Access Compliance Report Public Rights-of-Way (Curb Ramps)

Main Street: WAVERLY_PL Cross Street: CHANTILLY_LN Location: S

ADA ID: RPRK211020154017 Ramp Type: Type 4 - Parallel Initial Pass/Fail: Pass Overall Compliance: No Severity Score: 22

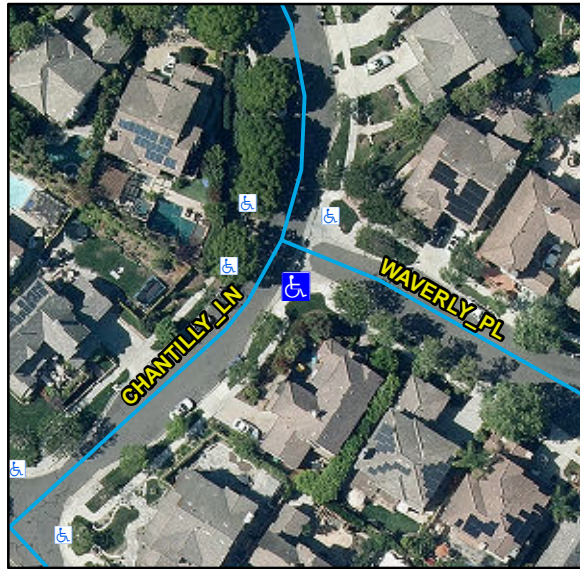
Compliance	Description	Data	Compliance	Description	Data
N/A	Ramp Length LT (in)	112	N/A	Ramp Length RT (in)	120
Yes	Ramp Width LT (in)	53	Yes	Ramp Width RT (in)	53
Yes	Ramp Run Slope LT (%)	7.3	Yes	Ramp Run Slope RT (%)	3.5
Yes	Ramp Cross Slope LT (%)	1.1	No	Ramp Cross Slope RT (%)	3.5
N/A	Landing Present	No	No	DWS Provided	No
N/A	Landing Length (in)	N/A	N/A	DWS Contrast	N/A
No	Landing Width (in)	N/A	N/A	DWS Length (in)	N/A
No	Landing Run Slope (%)	N/A	N/A	DWS Full Width	N/A
No	Landing Cross Slope (%)	N/A		DWS Offset Type	N/A
N/A	Landing Movement Obstructed?	No	N/A	DWS Offset Left (in)	N/A
	Landing Movement Type	Curb	N/A	DWS Offset Right (in)	N/A
N/A	Landing Shared	N/A			
N/A	Clear Space	Yes			
N/A	Clear Space To Crosswalk (in)	48			
N/A	Marked Crosswalk 1	No	N/A	Marked Crosswalk 2	No
	Crossing 1 Direction	NE		Crossing 2 Direction	NW
	Marked Crosswalk 1 Width (in)	N/A		Marked Crosswalk 2 Width (in)	N/A
N/A	Ramp Inside Crosswalk 1	N/A	N/A	Ramp Inside Crosswalk 2	N/A

Remove & Replace Curb Ramp With Two New Directional Ramps or Equivalent.
